SERVICE BULLETIN

APPLICABILITY: 2013MY BRZ

NUMBER: 12-139-12

SUBJECT: Specification Change to Front Bumper
 Fascia Mounting Brackets

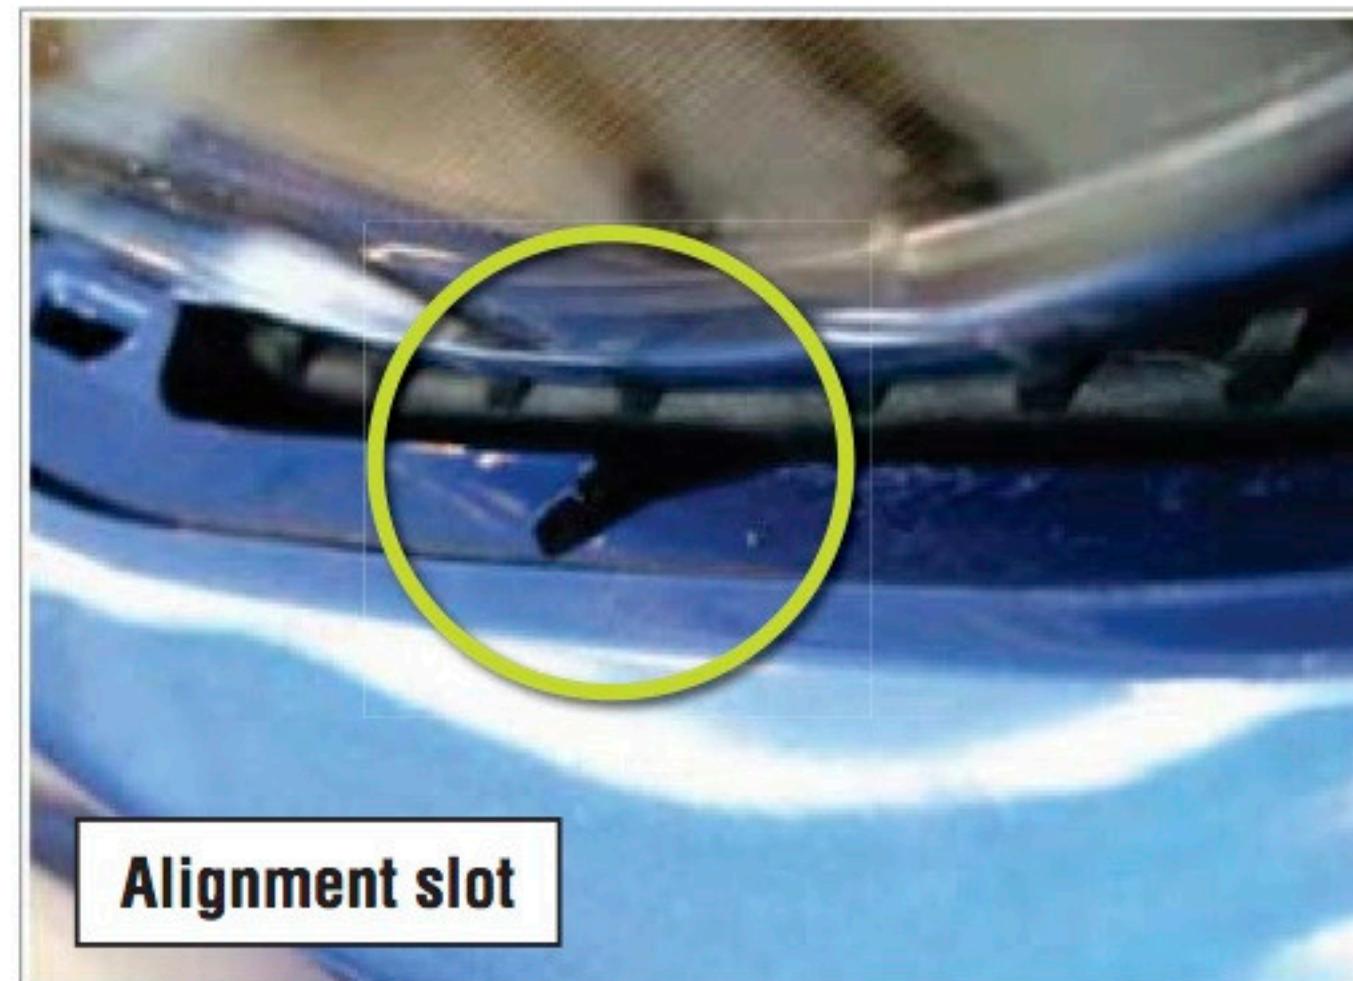
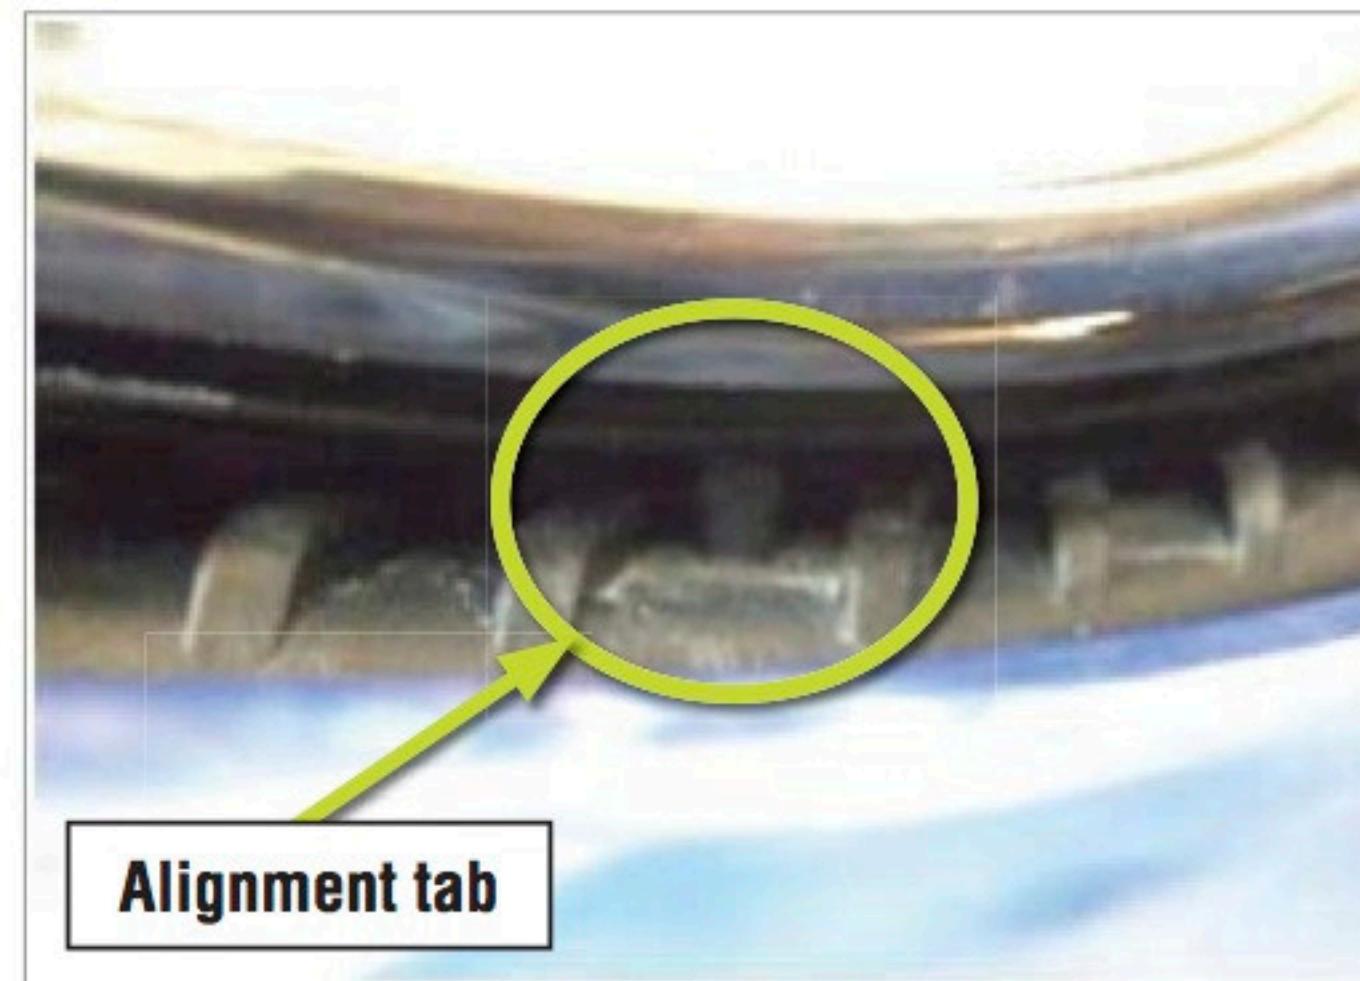
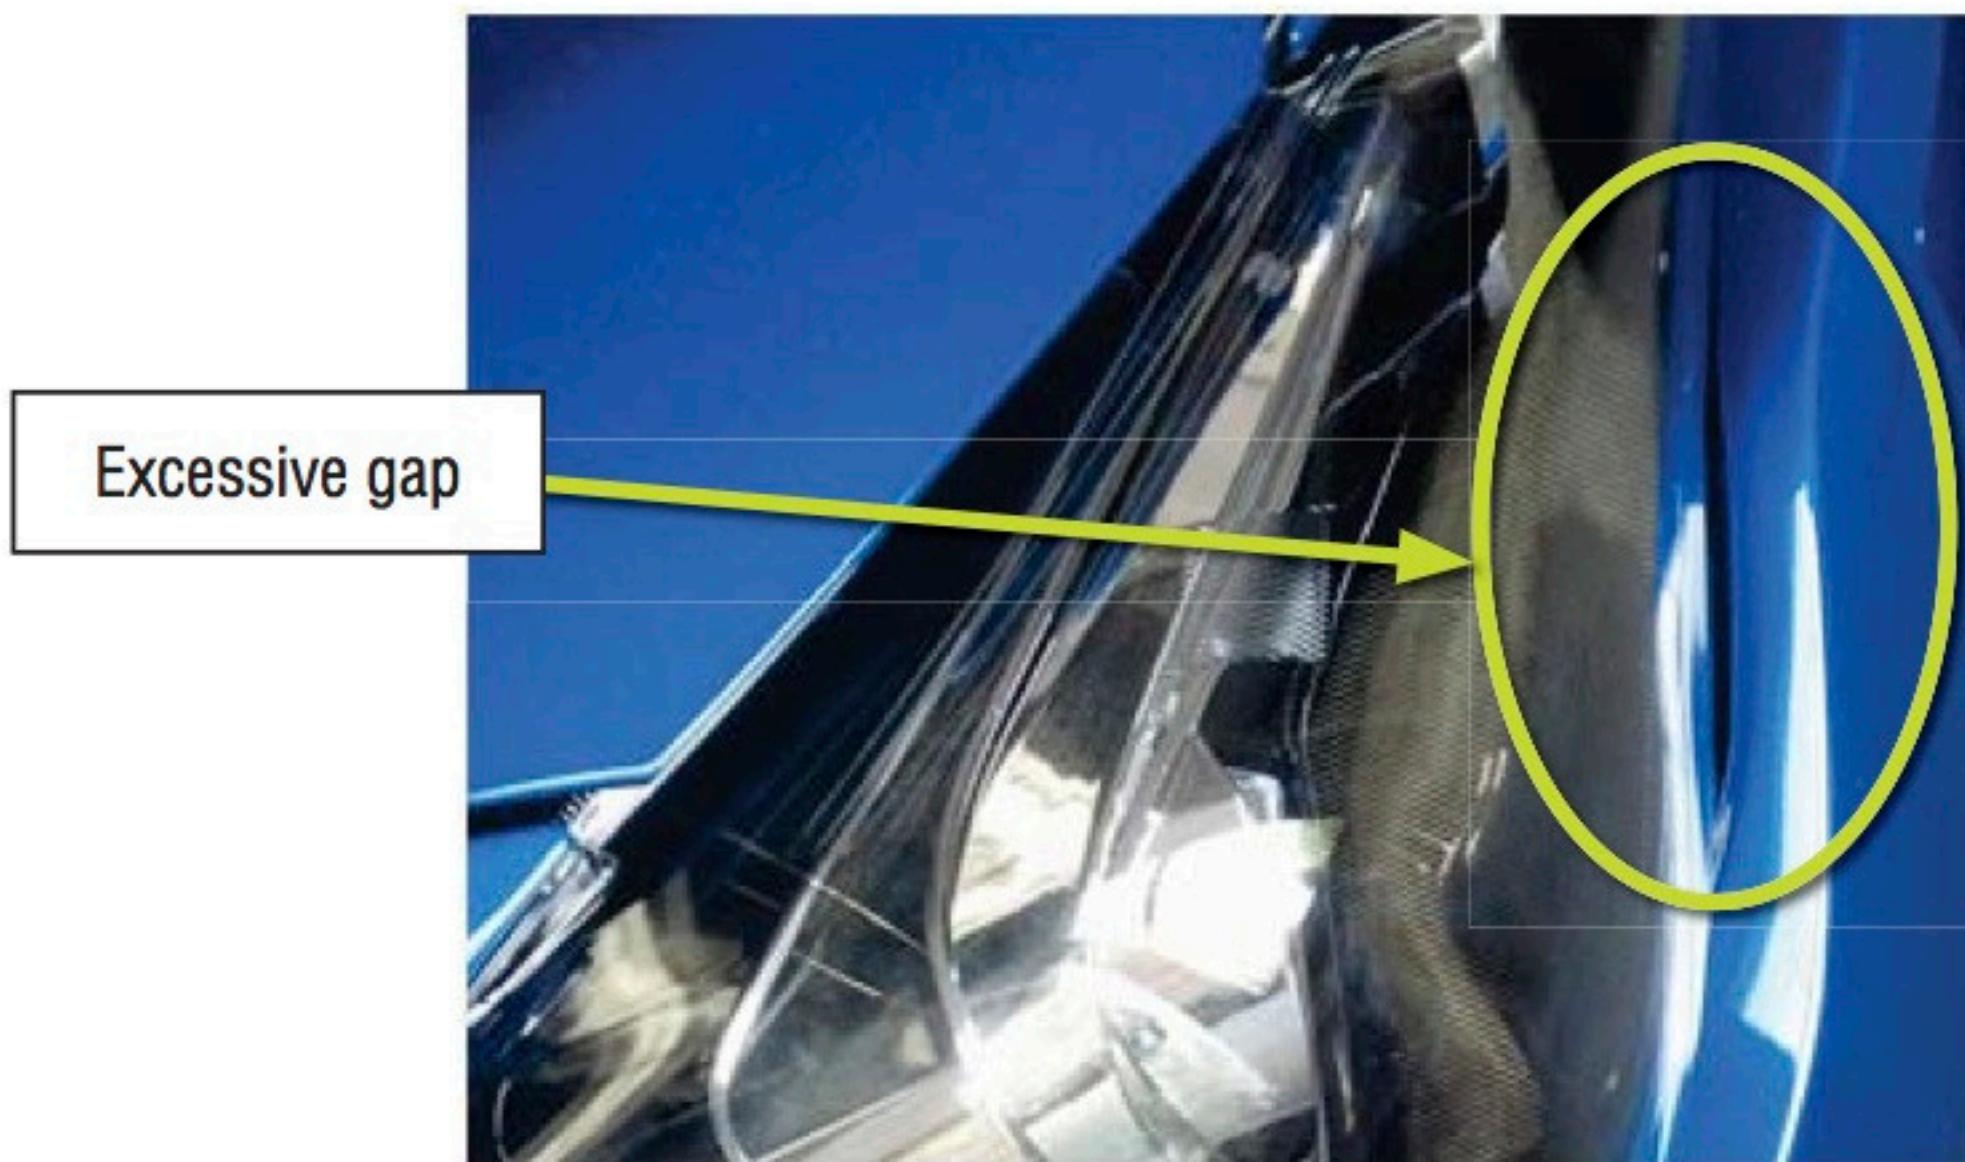
The photo below shows an excessive headlight gap which results when the alignment tab of the mounting bracket is not properly engaged into the alignment slot molded into the top rear edge of the bumper fascia.

The middle photo above shows the alignment tab portion of the mounting bracket under the center of the headlight. The photo directly above shows the alignment slot which is molded into the rear edge of the bumper fascia. The tab must fit into the slot **completely** for proper fit and alignment.

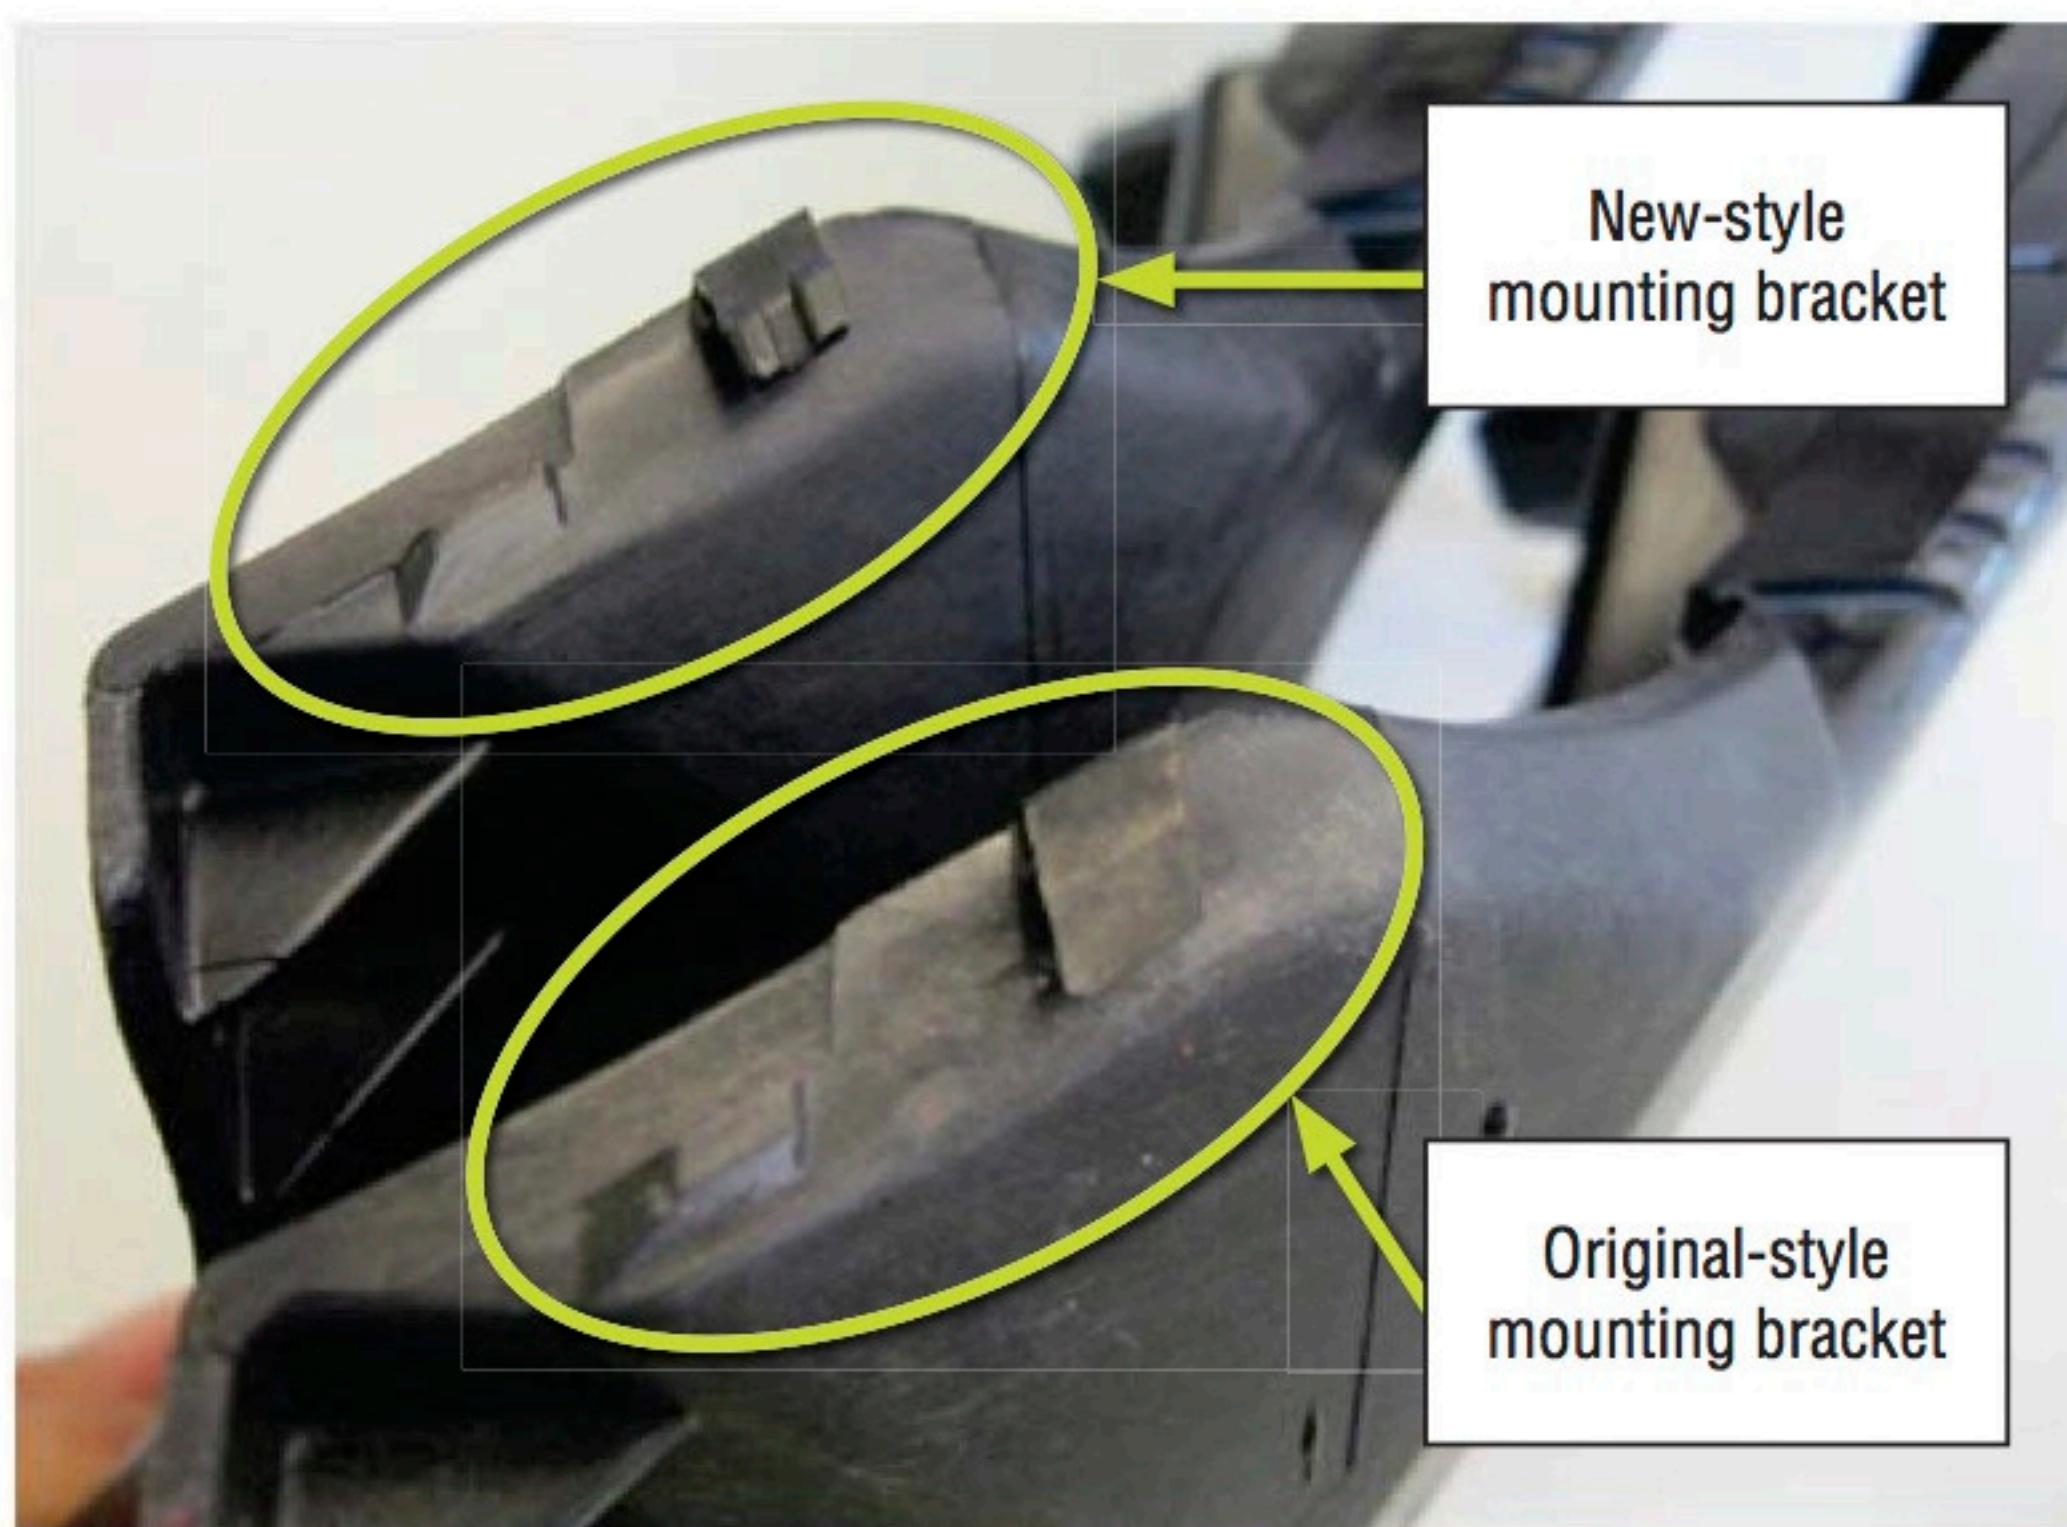
Follow the procedure outlined in the applicable Service manual for accessing and removing the bumper fascia mounting brackets. **NOTE:** Refer to Service Bulletin 07-68-12 for more information on removing the side marker lamps **BEFORE** attempting to remove them. The reference photo below shows the bumper fascia removed and a new mounting bracket installed.

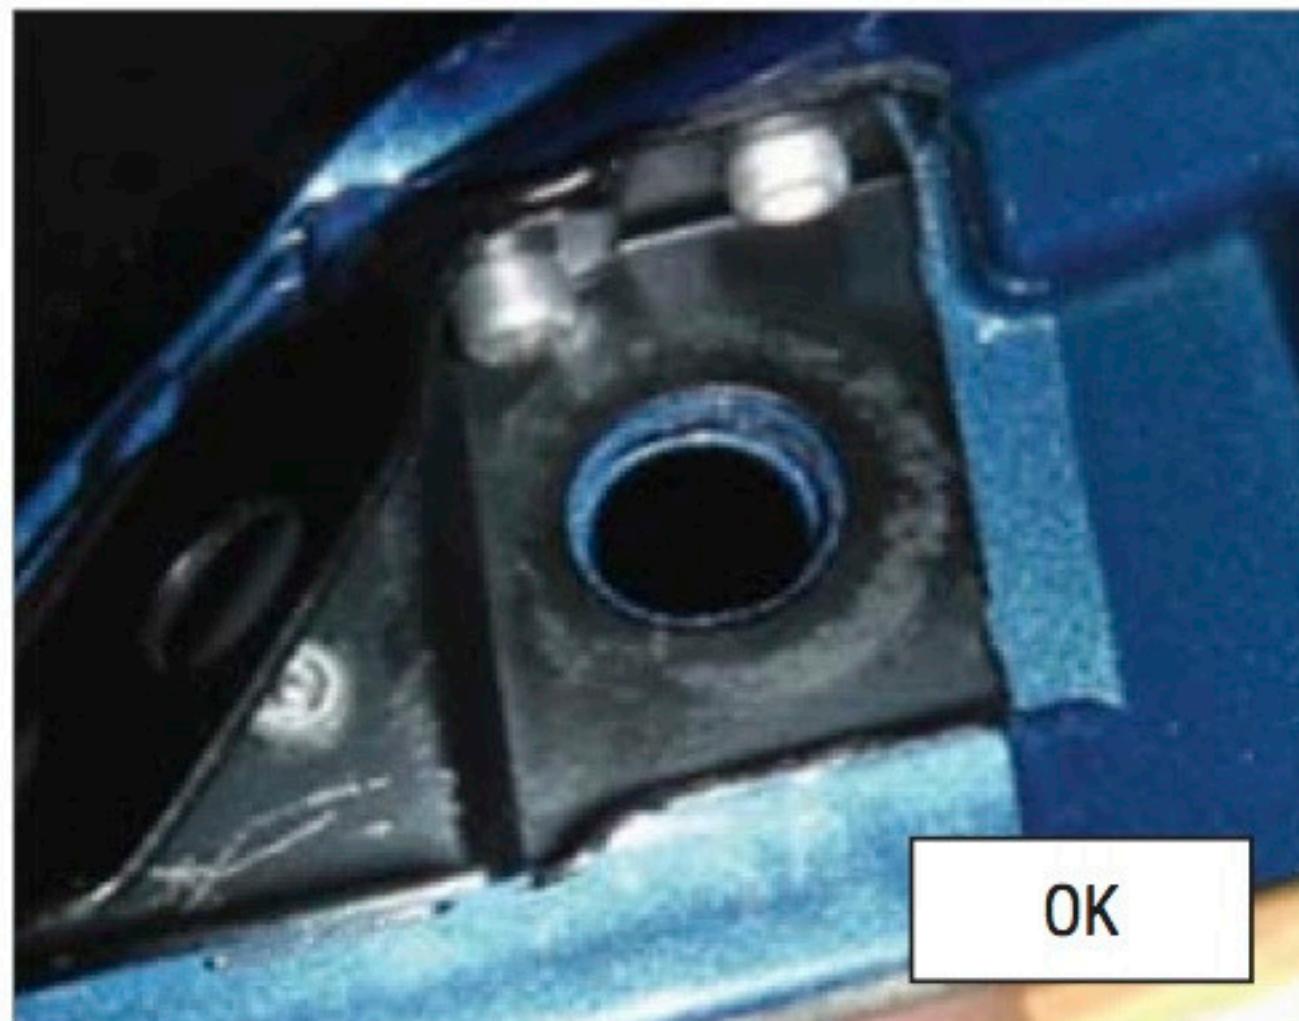
The design of the bracket has been revised to provide increased retention capabilities for the bumper fascia. Shown below is a comparison between the original-style bracket and the new-style.
